PLAN REVIEW SHEET

Petition: 2011-077

**WAITING PAD WITH 5'X15' BOX SHELTER
WITH PLANTING STRIP**

STD. NO.	REV.
60.04A

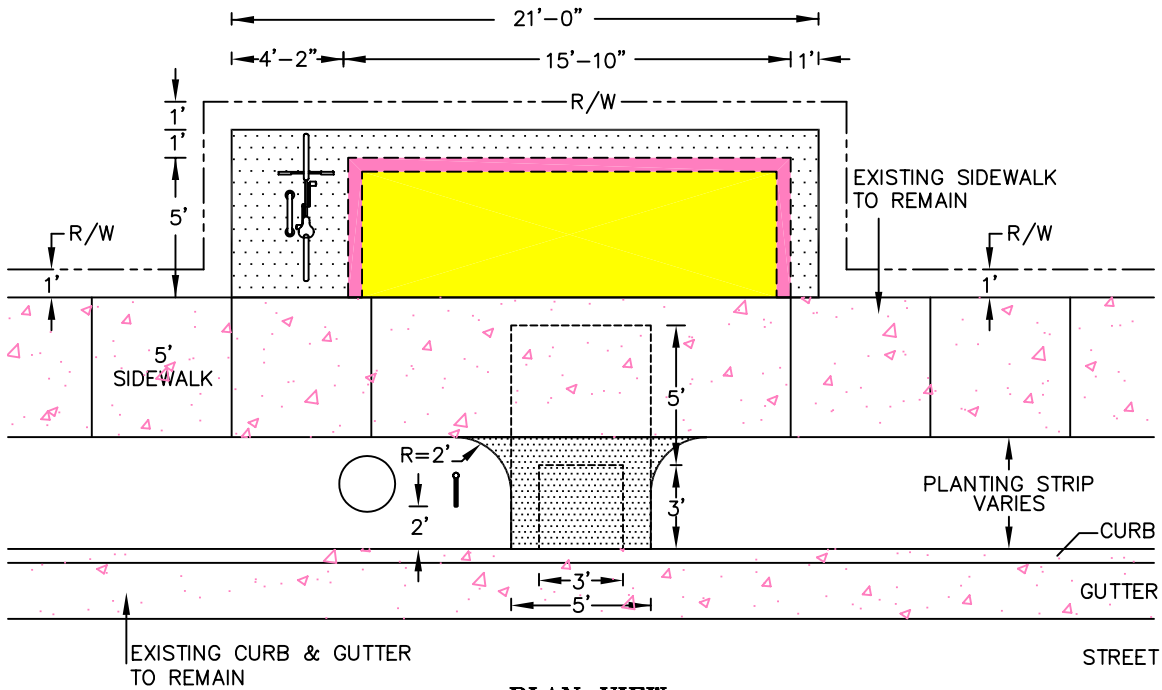
CATS requests that Petitioner install a concrete passenger shelter pad as depicted on the attached. If Petitioner has any questions regarding this request, please contact Ramond Robinson at CATS Service Development, 704.353-0018. Thank you.
